SUBJECT: CALLAWAY PLANT, UNIT 1 - STAFF ASSESSMENT OF INFORMATION PROVIDED PURSUANT TO TITLE 10 OF THE *CODE OF FEDERAL REGULATIONS* PART 50, SECTION 50.54(f), SEISMIC HAZARD REEVALUATIONS RELATING TO RECOMMENDATION 2.1 OF THE NEAR-TERM TASK FORCE REVIEW OF INSIGHTS FROM THE FUKUSHIMA DAI-ICHI ACCIDENT (TAC NO. MF3739)

STAFF ASSESSMENT BY THE OFFICE OF NUCLEAR REACTOR REGULATION

RELATED TO SEISMIC HAZARD AND SCREENING REPORT

CALLAWAY PLANT, UNIT 1

Figure 3.3-1 Plot of Staff's and Licensee's Base-case Shear-Wave Velocity Profiles for the Callaway site

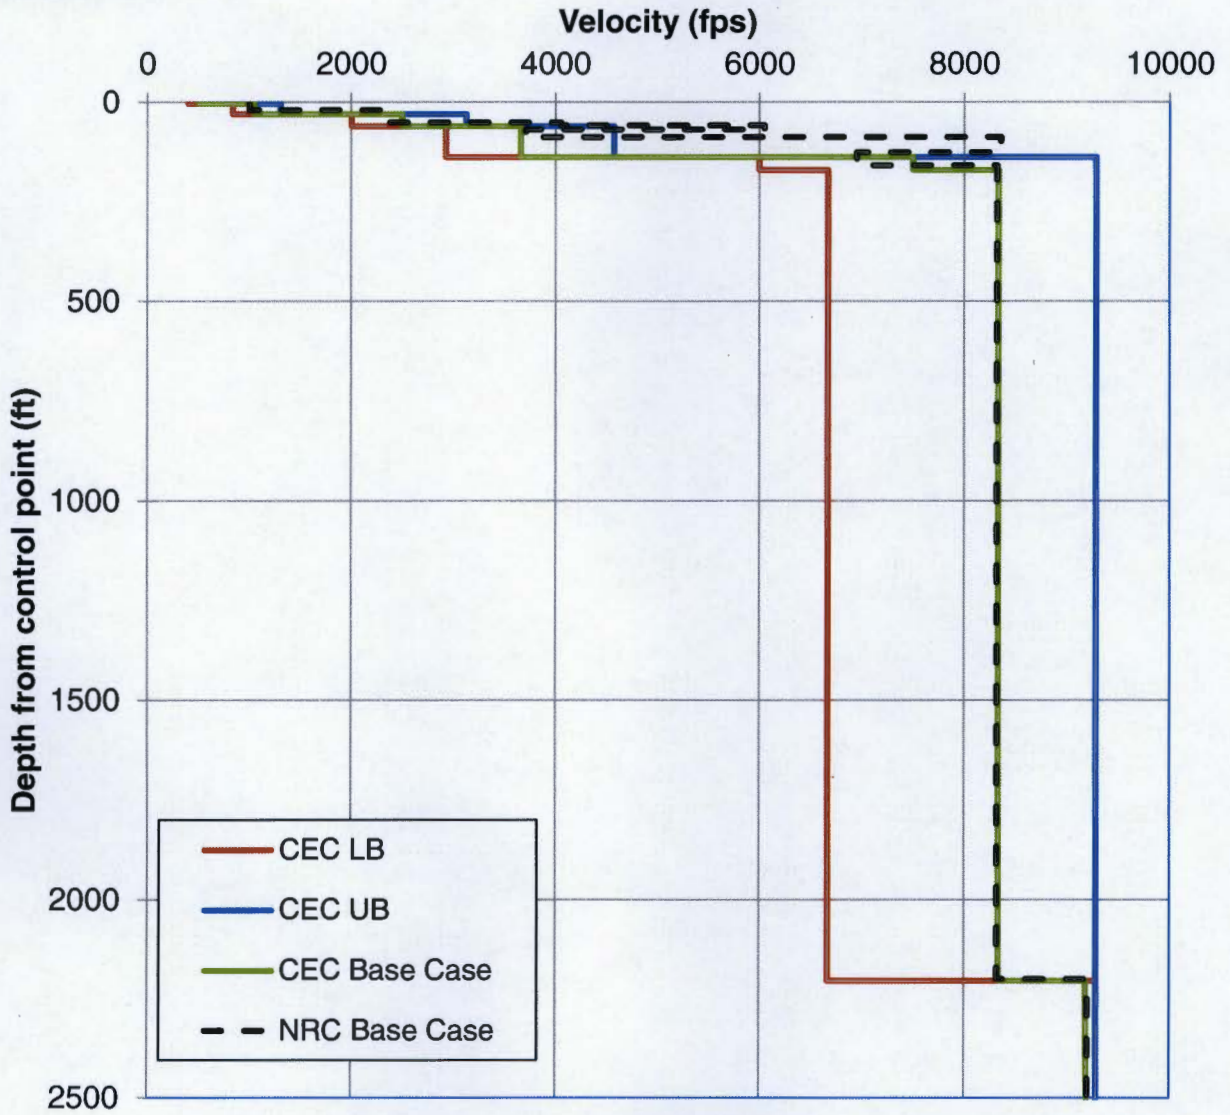
The Callaway, Unit 2 COL application site and the Callaway operating plant site are relatively close and the site geology is relatively uniform. As such, the NRC shear-wave velocity profile is based on the information provided in the Callaway, Unit 2 COL FSAR, except for the fill material which was assigned an average velocity of 1,000 fps (304 m/s). The staff used just a single base-case shear wave velocity profile to represent the site conditions, as significant data exist controlling the velocities and other properties at the site. Potential uncertainties in rock layer velocities are taken into account during the randomization process employed in site response calculations. In contrast, the licensee used three base-case profiles to represent velocity uncertainties at the site with recognition that even though the operating and proposed new sites are in close proximity, the site conditions are not identical. To capture the uncertainty in the depth to base rock beneath the site, the staff used a sigma of $\ln 0.15$, resulting in a basement uncertainty of about ± 300 feet. Figure 3.3-1 of this assessment shows the staff's velocity profile compared to the three base-case profiles developed by the licensee. Even though the licensee used three base-case profiles, the range between the lower and upper profiles is relatively small since the licensee used a natural log standard deviation of 0.2. As such, the velocity profile used by NRC and the three base-case profiles used by the licensee do not differ substantially.

Figure 3.3-1 Plot Comparing the Staff's and the Licensee's Median Amplification Functions and Uncertainties for the Callaway site

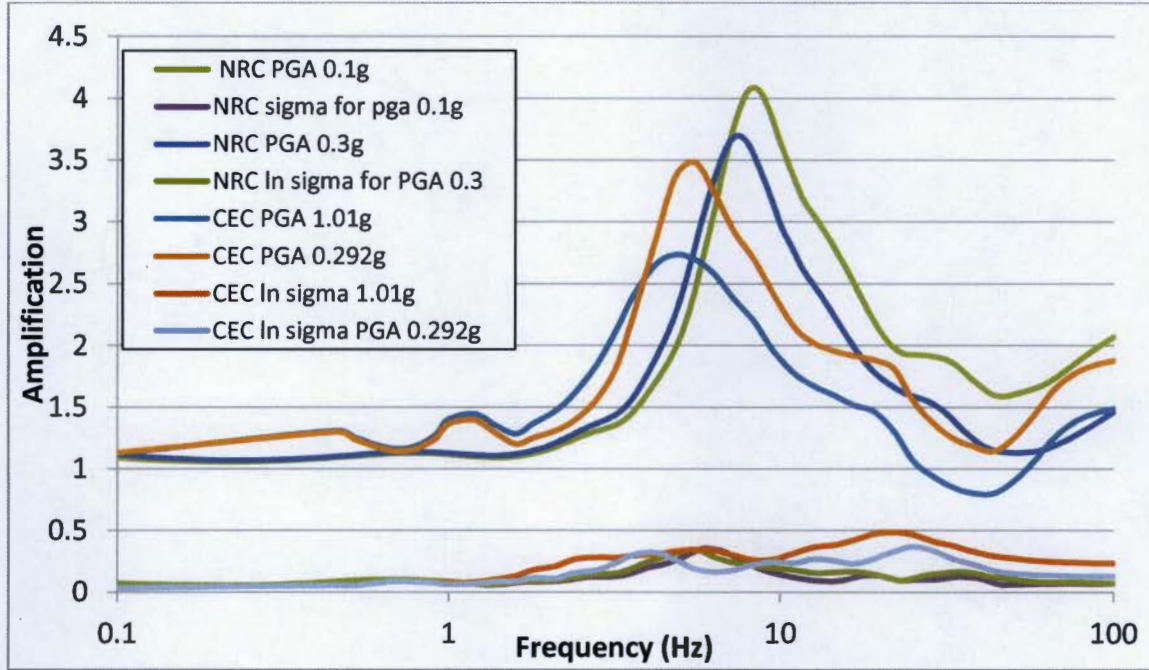
Figure 3.3-2 of this assessment shows a comparison of the staff's and licensee's median site amplification functions and uncertainties (± 1 standard deviation) for two of the eleven input loading levels. Both the staff's and the licensee's result indicate that there is strong site amplification between about 3 and 20 Hz.

Even though there are some variations in site amplifications due to differing input model parameters, overall the licensee's approach to modeling the subsurface rock properties and their uncertainty results in similar amplification factors as those developed by the staff. In addition, as shown in Figure 3.3-3 of this assessment, when calculated using these amplification functions the staff's and licensee's control point seismic hazard curves are similar. Appendix B of the SPID provides guidance for performing site response analyses, including capturing the uncertainty for sites with less subsurface data; however, the guidance is neither entirely prescriptive nor comprehensive. As such, various approaches in performing site response analyses, including the modeling of uncertainty, are acceptable for this application.

Figure 3.4-1 Comparison of the Staff's GMRS with Licensee's GMRS and the Callaway Unit No 1 SSE

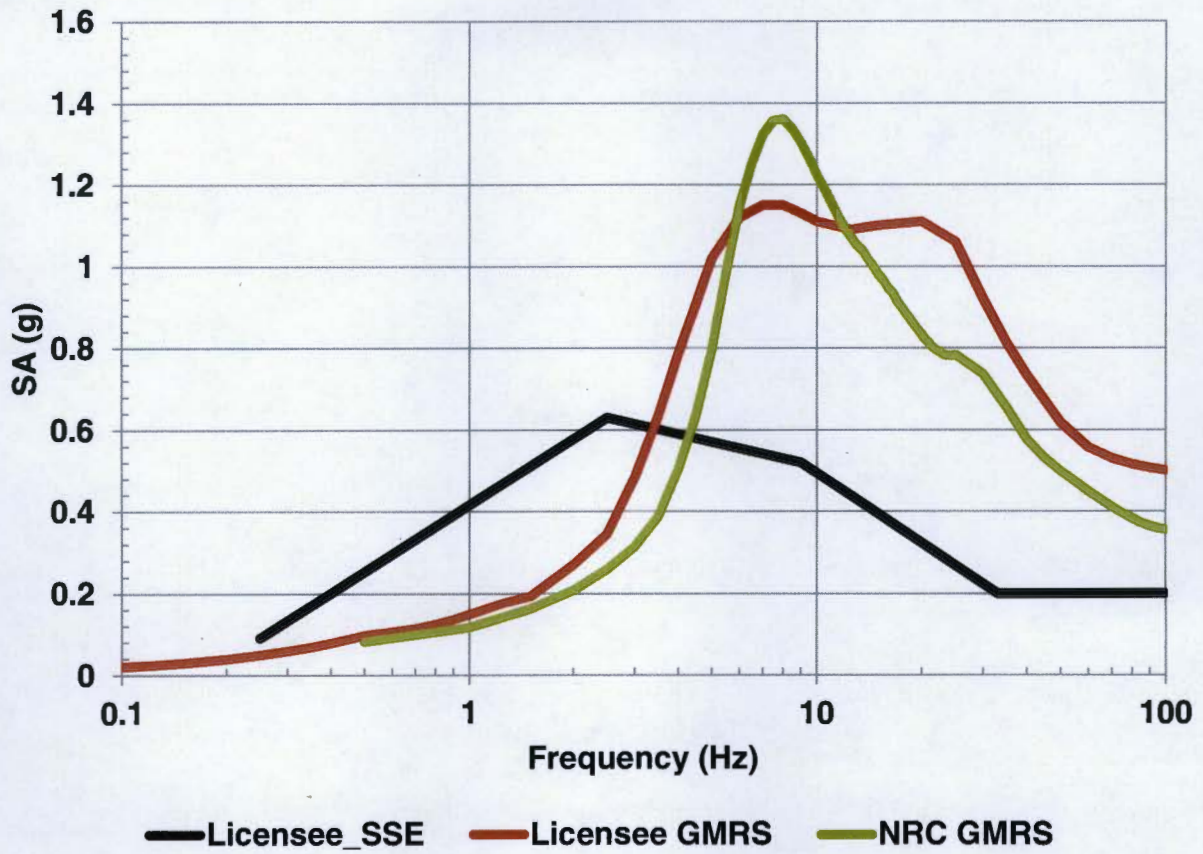
The staff independently obtained the 10^{-4} and 10^{-5} UHRS using the results of its confirmatory PSHA and site response calculations described in Sections 3.2 and 3.3 of this staff assessment, respectively. Figure 3.4-1 of this assessment shows a comparison of the GMRS determined by the licensee to that determined by the staff.

As shown in Figure 3.4-1 below, the licensee's GMRS shape is generally similar to that calculated by the staff. The staff concludes that the small differences between the two GMRS are due to the differences in base-cases, with the licensee using three base-cases and the staff using one base-case profile. The staff concludes that these differences are acceptable for this application because the licensee followed the guidance provided in the SPID with respect to both the PSHA and site response analysis for the Callaway site.
